**Amendment No. 1 to Clean Water Act Section 401
Water Quality Certification No. R9-2012-0008**

**PROJECT: Terracina Project
Certification Number R9-2012-0008**

**APPLICANT: LS Terracina, LLC
355 East Rincon, Suite 300
Corona, CA 92879**

Figure 4

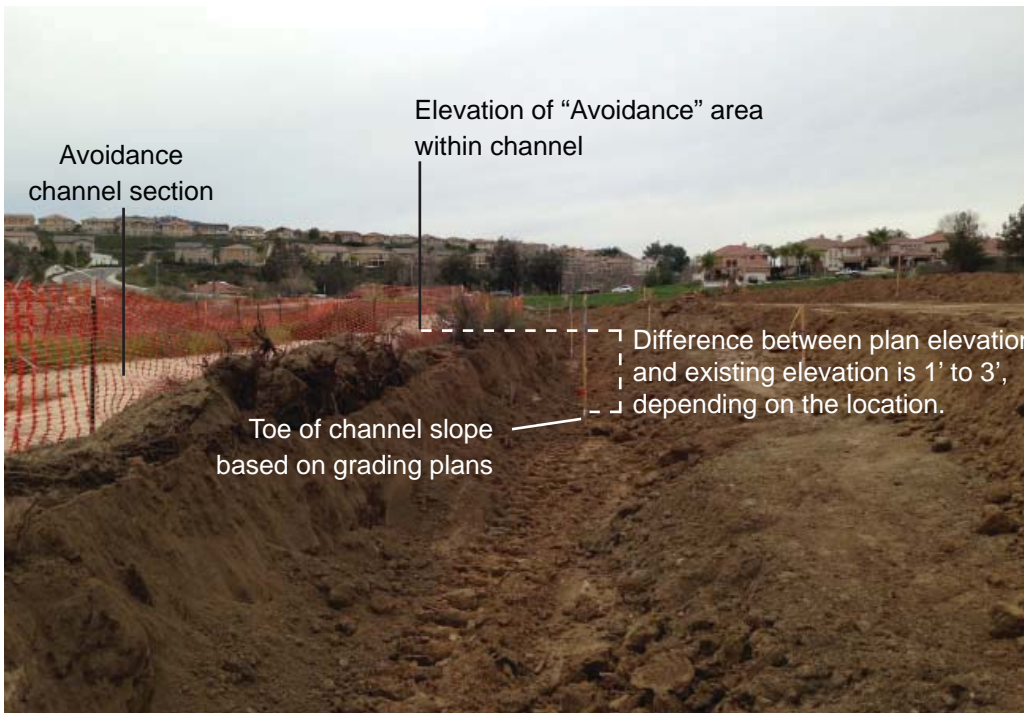
Section of channel designated for avoidance.

Elevation on grading plans do not align with actual elevations. The result is avoidance area of channel is 3' - 4' above final grade of non-avoidance areas of channel.
